WARRANTY BULLETIN

Wb02-01

SUBJECT ENGINE COMPARTMENT DOORS NEW: OPENING MECHANISM

| Model                                      | VIN PREVOST CAR NO.  |  |
|--|--|--|
| XL2-45 Coaches<br>Model Year : 2000 - 2002 | From 2PCX33495 <u>Y</u> 102 <u>6951</u> up to 2PCX33497 <u>2</u> 102 <u>7879</u> incl. |  |

FIGURE 1: FORMER OPENING MECHANISM

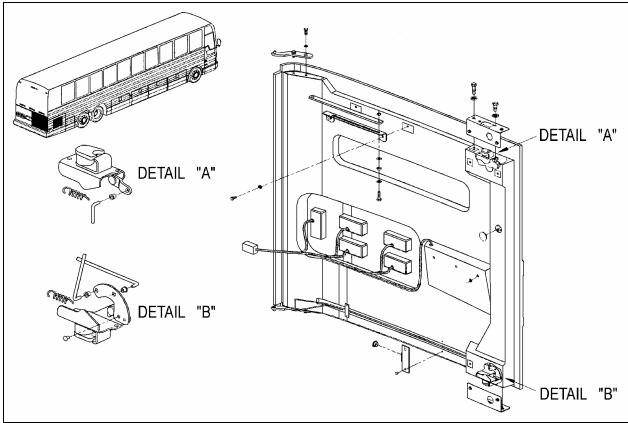
On the above mentioned vehicles, the engine compartment doors opening mechanism must be modified in order to improve operation and to avoid parts corrosion.

- 1. Open engine compartment doors.
- 2. Remove former opening mechanism: control rod with brackets, upper and lower latches and pin strikers (refer to figure 1).

FIGURE 2: ENLARGEMENT OF OPENING

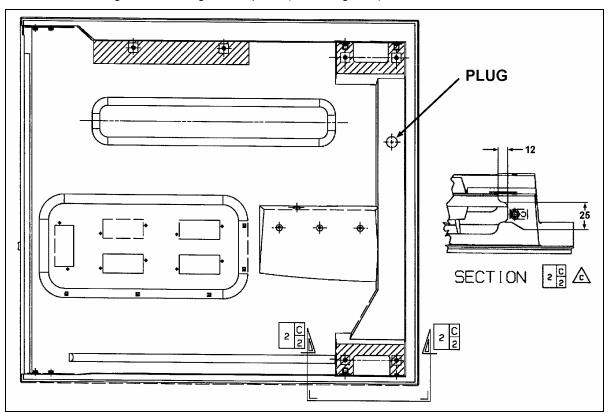
- 1. Insert upper latch rod (287381) into O'Ring (507212) then into upper latch support (287382).
- 2. Fasten upper latch support to main upper support (287270) using two cap screws (502531) and two lock washers (502582).
- 3. Feed connecting rod (287276) through slot in the upper latch rod (287381) then insert connecting rod through the opening in the door upper section. Temporarily fasten upper latch using 4 cap screws (502531).
- 4. Grind or file the opening as per dimensions indicated in figure 2. Make sure plug is in place to prevent dirt from disturbing mechanism, glue if required (refer to figure 2).

FIGURE 5: LOCATION OF "Z" PLATES

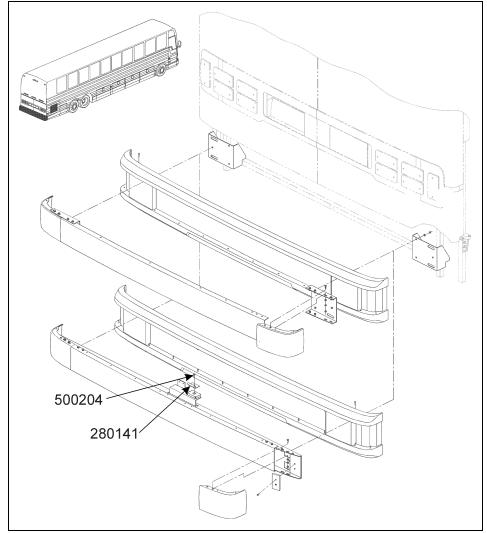
12. Install two "Z" plates (280141) in place of the pin strikers (refer to figure 5).

FIGURE 6: NEW OPENING MECHANISM

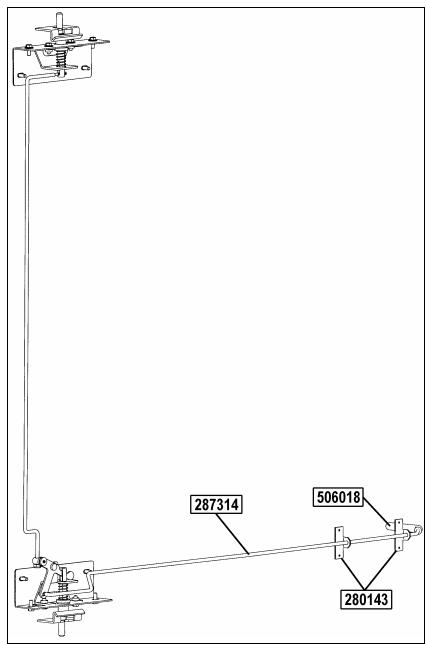
- 9. Install control rod (287314) into its housing then feed control rod through pivot hole (287277). Insert pivot into slot of lower latch rod (287272). Fasten lower latch support (287291) to main lower support (287275) using two cap screws (502531) and two washers (502582) then secure lower latch using four cap screws and four washers.

- 10. Fasten two control rod brackets (280143) then install handle (506018).
- 11. Make sure opening mechanism works properly and adjust as required.
